T99X171 SKBB OTT box

Sample issues

Top cover issue 1

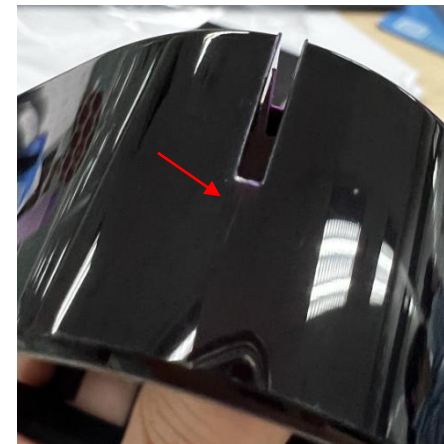
Issue 1: Welding lines

Cause: In order to improve gas marks of top surface and burr of light pipe hole, reduce the injection speed and pressure. So welding lines has not been improved.

Action: T2>T3>T4: Because there were other problems(gas mark/burr) at the same time, it was impossible to do much about this problem.

Now: Tooling modification to add material on the mold gate for gas marks improvement. We will add injection speed and pressure for next tooling tryout. But due to characteristic of injection mold there is always weld line around hole. We will do the best to follow the previous samples (PC).

Top cover issue 2

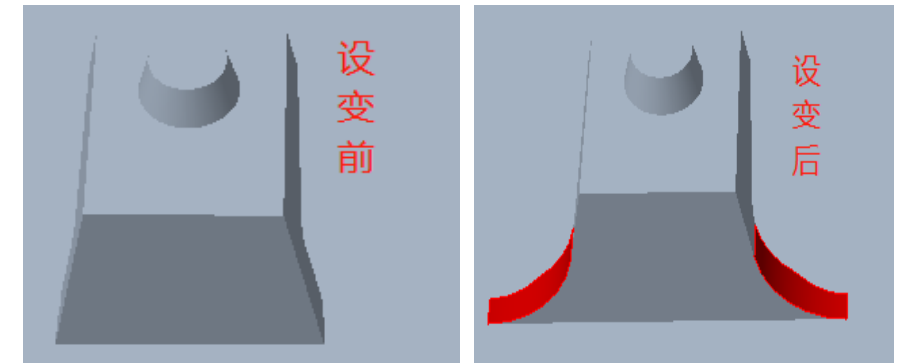
Issue 2: Gas Marks

Cause: Because the texture was finer than T3, The gas marks were more obvious than T3.

Action: Tooling modify to add material on the mold gate for gas mark improvement. Due to characteristic of injection mold and structure of this part, there will be gas marks, stress marks on the cosmetic surfaces, But We will do the best to follow the previous samples (PC).

Light pipe issue

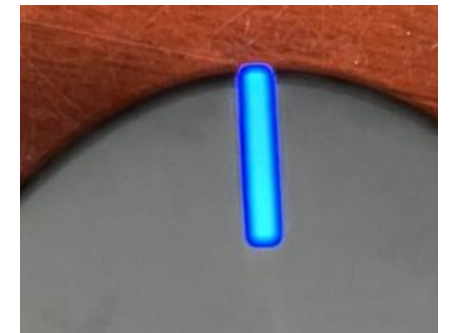
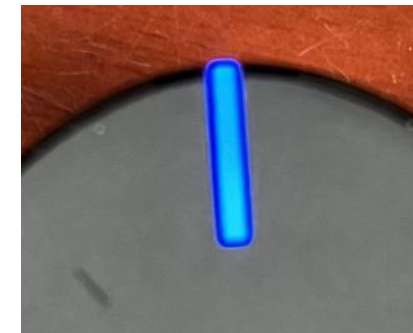
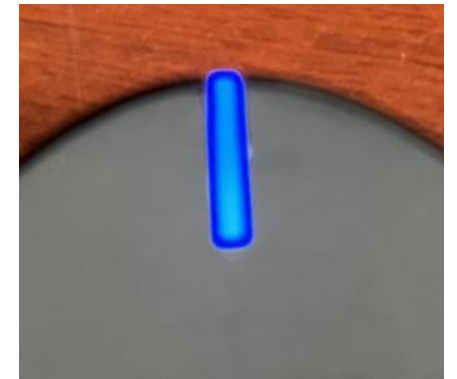
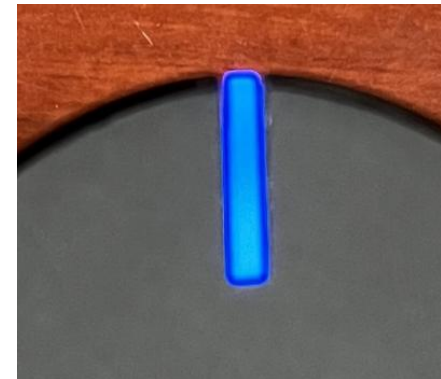
Issue : The chamfer of light pipe is not smooth.

- LED leans

- The light emitting surface is not uniform
- Make this point surface the same as the other

Action: T1>T2: The chamfer is severe drag on T1. Checked and modified the corner of mold. T2 samples had much improved, but it is still exist on T2 samples.

T2>T3: Re-checked and modified the corner of mold again and redo the texture. The chamfer of T3 sample is okay.
